# Service Bulletin

Bulletin No.: 21-NA-148

**Subject:** Diagnostic Aid – DTC P2797, P2798 or P0C2D for Transmission Fluid Pump Performance

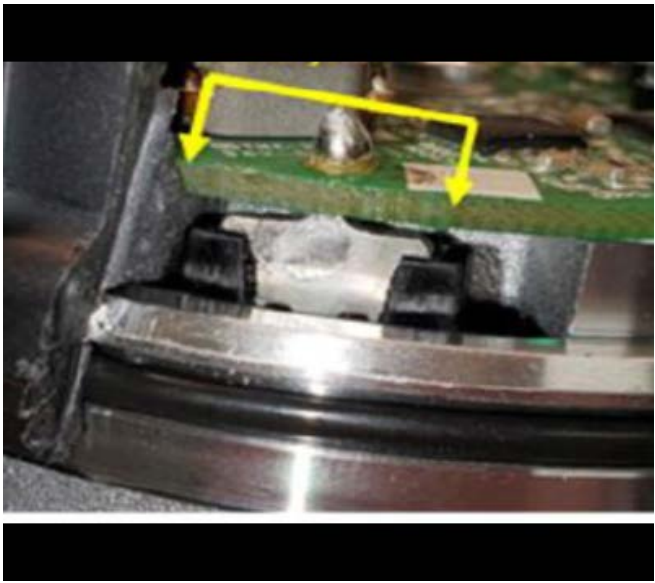
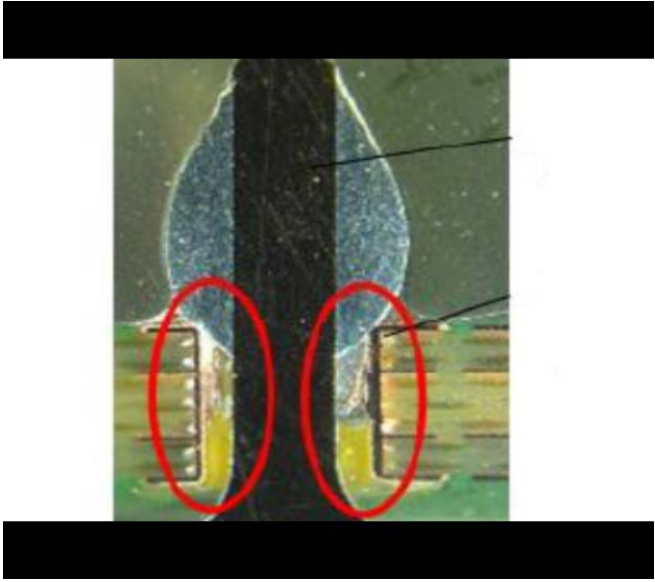
<p>Cause</p>	 <p>5867264</p>  <p>5867265</p> <p>A part quality spill has been identified with the low voltage electric transmission fluid pump attached to the driver side of the transmission. A soldering process was out of specification like the illustration above.</p> <p><b>Note:</b> The pump motor is not internally serviceable and the pictures provided are only for helping to visually show the issue.</p>
<p>Correction</p>	<p>Replace the transmission fluid pump.</p> <p><b>Important:</b> The pump motor is not internally serviceable.</p>

If you encounter a vehicle with the above concern, replace the transmission fluid pump. Refer to *Transmission Fluid Pump Replacement* in SI.
